BOARD ACTION REPORT – APPEALABLE ITEM

Project Name: Delray Square II
Project Location: 14530 South Military Trail
Request: Approval of a Class I Site Plan Modification
Board: Site Plan Review and Appearance Board
Meeting Date: July 25, 2018

ITEM: **Delray Square II (2018-130):** Class I Site Plan Modification associated with architectural elevation changes involving the addition of tower features and stone columns, and improvements to the existing roof and canopies.

REVISION PER COMMENTS DATED JUNE 21st 2018

JOB NUMBER	15089
SCALE	AS NOTED
ISSUE DATE	15.11.24
PERMIT DATE	
BID DATE	
DRAWN BY	dpt
CHECKED BY	MW
DISCIPLINE	ARCHITECTURE
PLAN TYPE	
SHEET NUMBER	A3.02

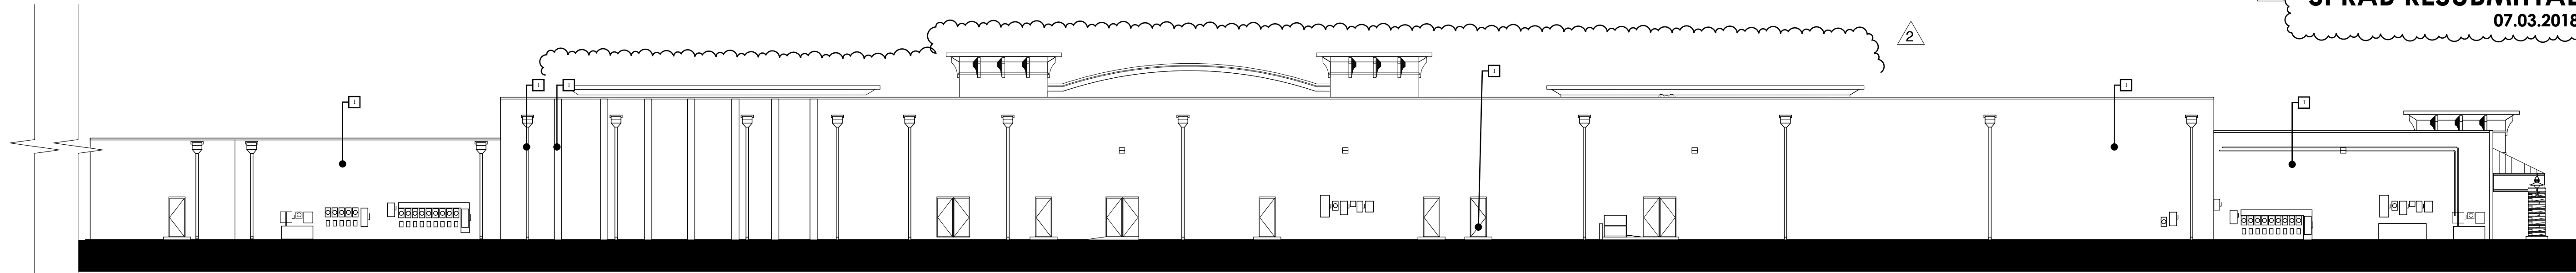
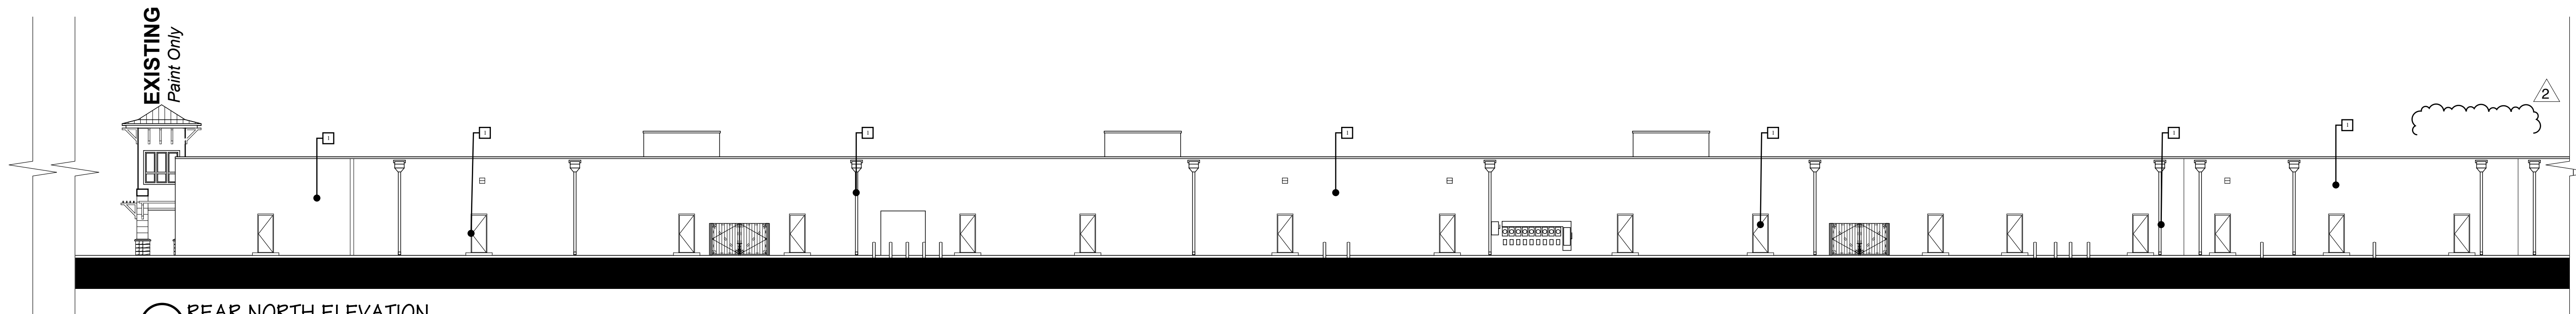
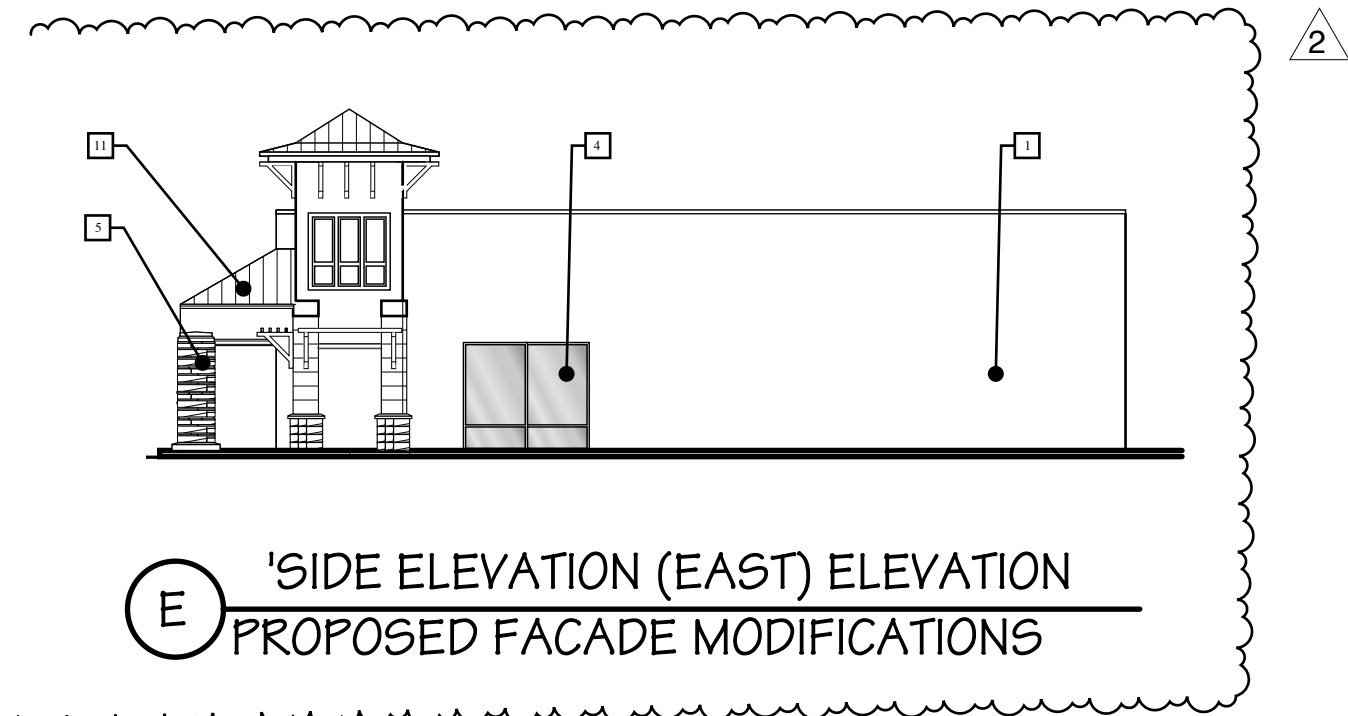
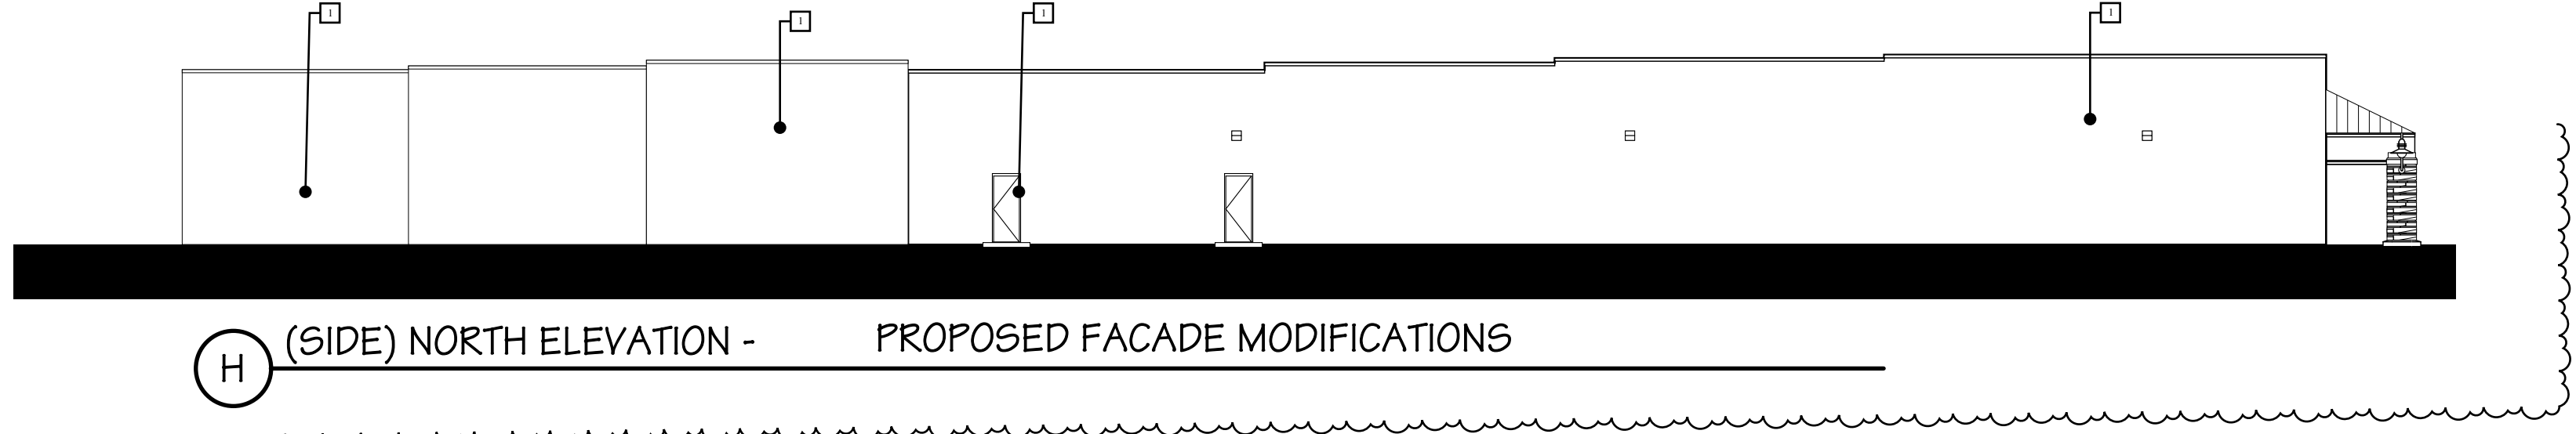
The rear elevation drawings (Sheets AC3.02 & A3.02) have been revised so that the south elevation projections above the rear parapet match the proposed work. Additionally, the fourth tower has been removed as only three towers are being proposed. Material tags indicating colors, etc have been added to the color elevations. Please note, these tags were already shown on the black and white elevations previously submitted and are being resubmitted.
